SUBJECT: CERTIFICATION OF THE MINUTES FOR THE MEETING
 OF THE ADVANCED BOILING WATER REACTOR
 SUBCOMMITTEE, APRIL 6, 2011 IN ROCKVILLE,
 MARYLAND

**ADVISORY COMMITTEE ON REACTOR SAFEGUARDS
ADVANCED BOILING WATER REACTOR SUBCOMMITTEE
MEETING MINUTES
April 6, 2011**

The purpose of the meeting was to hear presentations and discuss the information on Chapter 10 and 14 of the Safety Evaluation Report (SER) related to the Combined Operating License (COL) application submitted by South Texas Project Nuclear Operating Company (STPNOC, applicant) for two ABWR units at the South Texas Project (STP) site in Texas. The Subcommittee did not receive written comments from members of the public. There were no requests to make oral statements from members of the public regarding the Subcommittee meeting. Ms. Maitri Banerjee was the Designated Federal Official (DFO) for this meeting.

Figure 10.2-5 Turbine Overspeed Trip System Functional Diagram

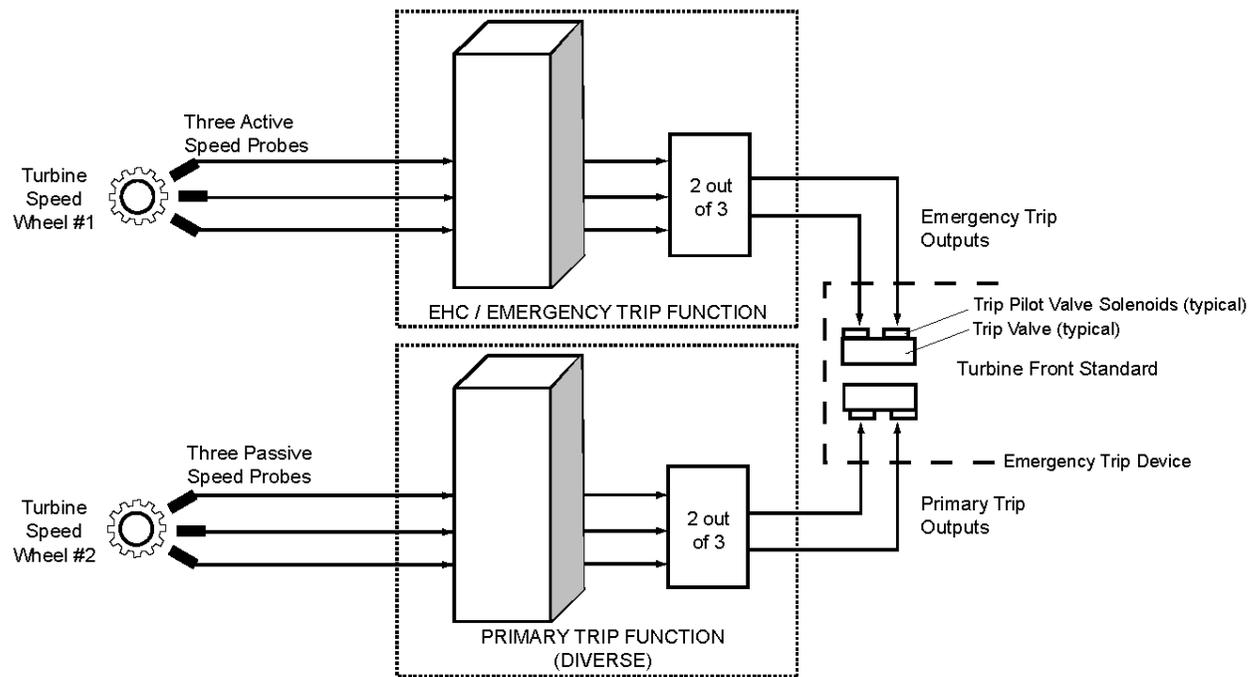
3 The picture we've got here in front of us
4 will be will be added to the FSAR. It's a simplified
5 diagram of the two overspeed trip functions -- how
6 they're implemented.

11 MEMBER BROWN: Okay. I just want to make
12 sure after going through this and the clarifications
13 you all added to the RAI. There are three active
14 speed sensors that are also used for the normal speed
15 control?

6 MR. MURRAY: What I mentioned was if they
7 exceed setpoint. But also in the information we
8 provided, yes, if you have one failure, you do not get
9 a turbine trip. You go to a two out of -- or you
10 reduce the logic -- go two out of three. But a second
11 failure of a speed probe will provide a trip.

RAI 10.02-4 revised response added a figure to FSAR Section 10.2:

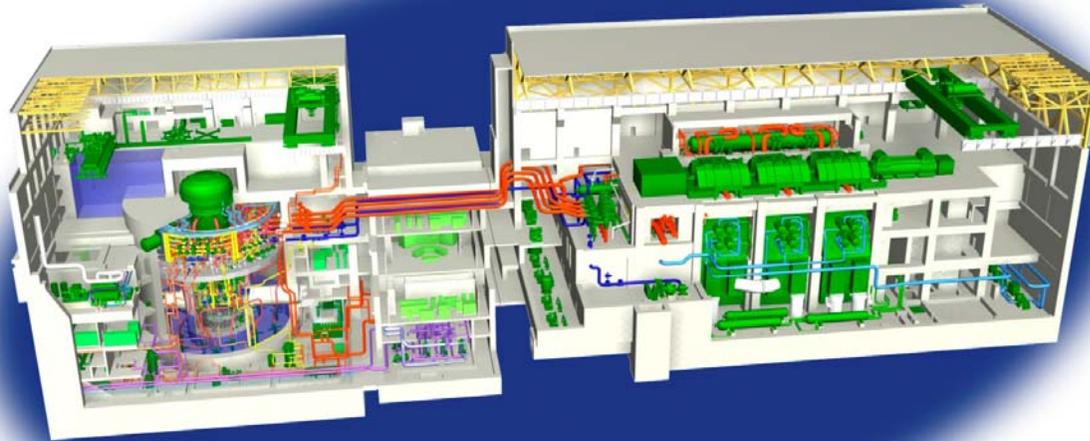
21 Now we also revised a previous response to
22 RAI 10.04.07-3. And we revised a Tier I figure --
23 2.10-2a -- which shows condensate booster bumps on
24 that Tier I figure for consistency.

14 In reviewing that change, we looked at the
15 Tier 1 information, and there appeared to be an
16 inconsistency between the Tier 2 information and the
17 Tier 1 information which they had incorporated from
18 the DCD by reference.

19 The first slide here pretty much
20 summarizes what the issue was when we came and talked
21 to you last time at the ACRS meeting. And basically
22 like I just said, we had a Tier 2 change that changed
23 system configuration, and the Tier 1 information still
24 reflected the DCD information which didn't incorporate
25 condensate feedwater system that utilizes a booster

3 In resolution, they provided us with a
4 revision to one of our earlier RAIs. And in that
5 revision what they did was they revised the figure
6 that the design description pointed to -- or the ITAAC
7 pointed to design description figure to confirm that
8 the system in the ITAAC was the system that we were
9 approving in the design. And they updated that
10 figure, and now the figure shows the condensate pump
11 -- the relative location of the condensate pump. And
12 it includes the condensate, moves the pump into Tier
13 1 figure.

14 So based on that, we reviewed that. We
15 looked at the Tier 2 information and with the revised
16 RAI response, we now feel like this issue is resolved
17 and the open item can be closed.

- The applicant proposed a new Tier 1 departure which revised Tier 1, Figure 2.10.2a.
- In the revised Figure 2.10-2a, condensate booster pumps are now included as part of the basic CFS configuration.
- The staff reviewed the proposed revisions to the Tier 1 information and found it acceptable since the information in Tier 1 is now consistent with the plant design described in Tier 2.
- Incorporation of the proposed Tier 1 change is being tracked as a confirmatory Item.

Primary Overspeed Trip and Emergency Overspeed Trip Functions

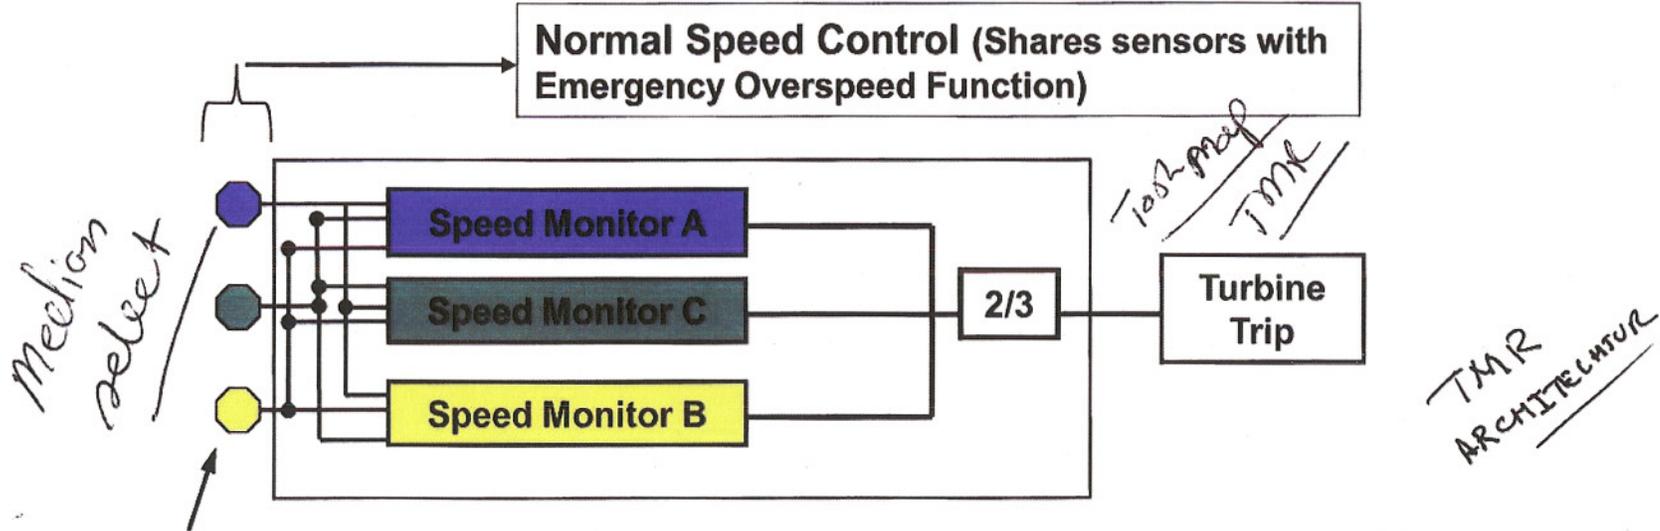
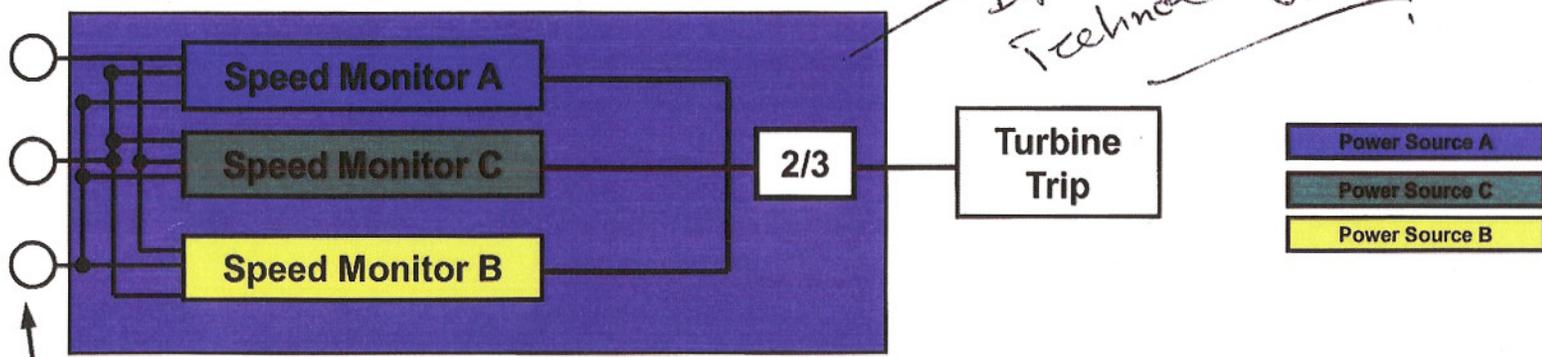
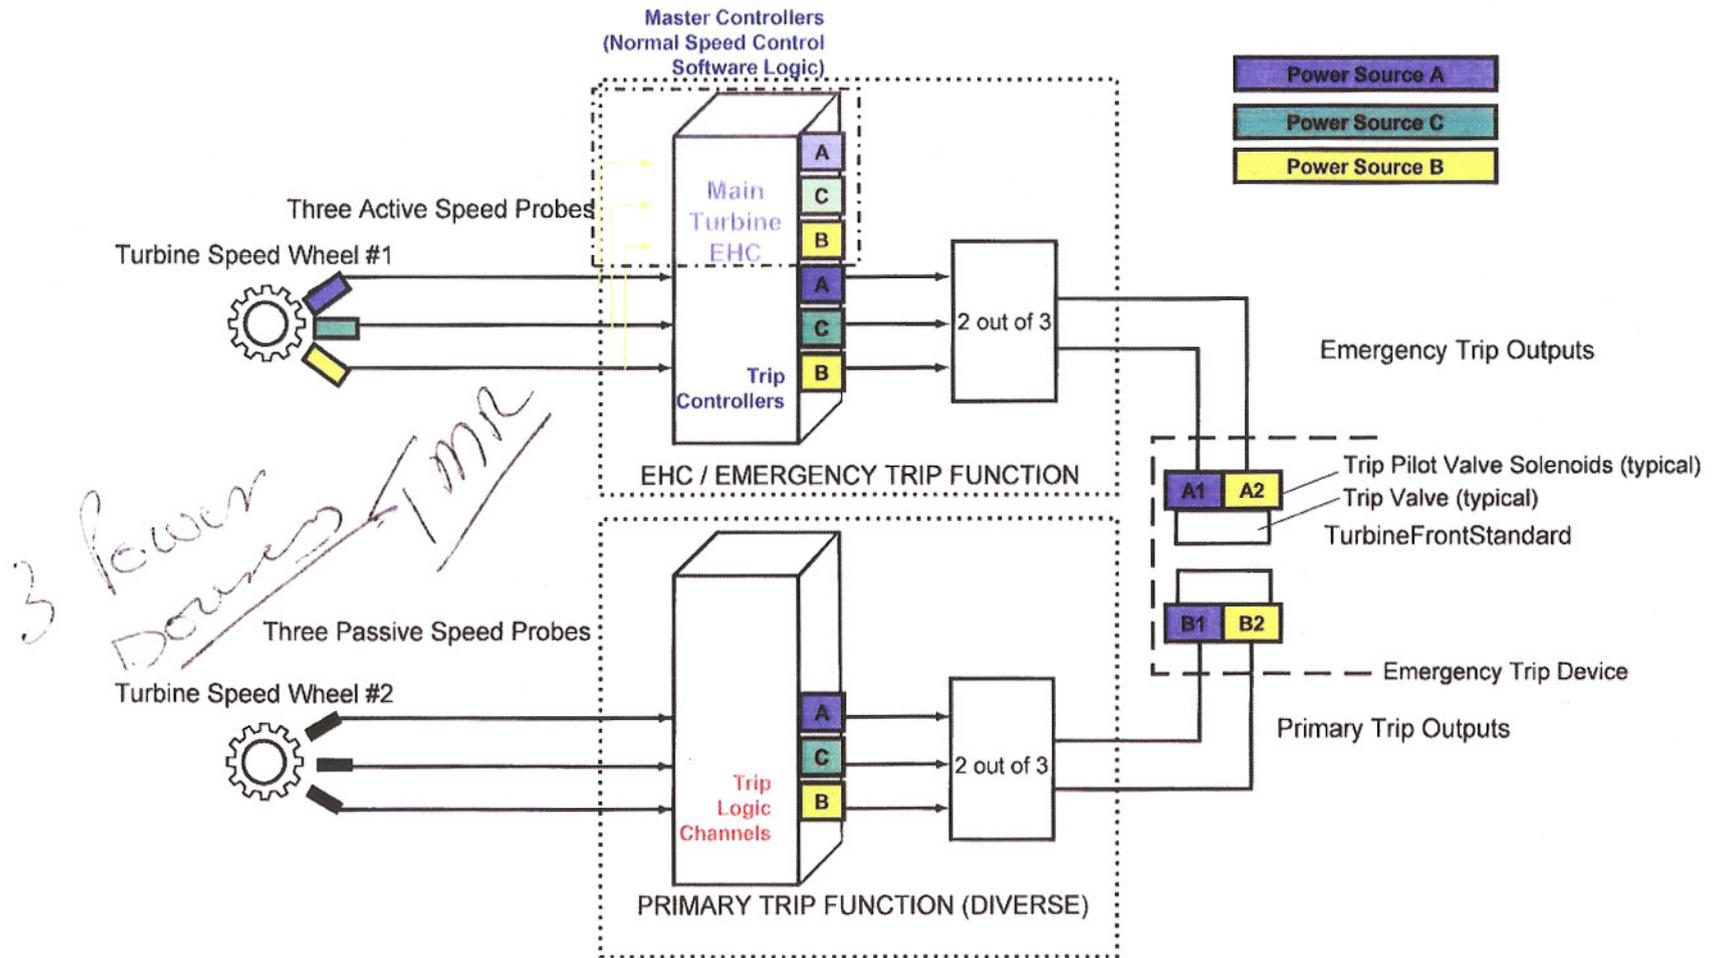
8 Whatever the mode of failure, we haven't
9 got that defined as to what defines a failure, et
10 cetera. And in my previous reading, I kind of felt
11 that applied to the primary diverse system also. But
12 then I went back and looked through and I could not
13 find that in the RAI response, anything that addresses
14 the passive sensors such that if two of them fail --
15 whatever the mode either -- there's no output or the
16 output goes bananas or whatever the thing is that
17 stays in one place -- couldn't find any reference to
18 if you lost sensing on the primary system that you
19 would get a turbine trip. So am I wrong?

3 MEMBER STETKAR: I think, Dinesh, my
4 questions to the Applicant kind of get to the point of
5 what happens if a speed signal -- two out of three
6 speed signals go to zero speed is basically what I was
7 looking for.

3 Speed Pickups (Active) for Emergency Overspeed Trip Function
(Active detector needs power supply)

3 Speed Pickups (Passive) for Primary Overspeed Trip Function
(Each passive detector needs no power supply)
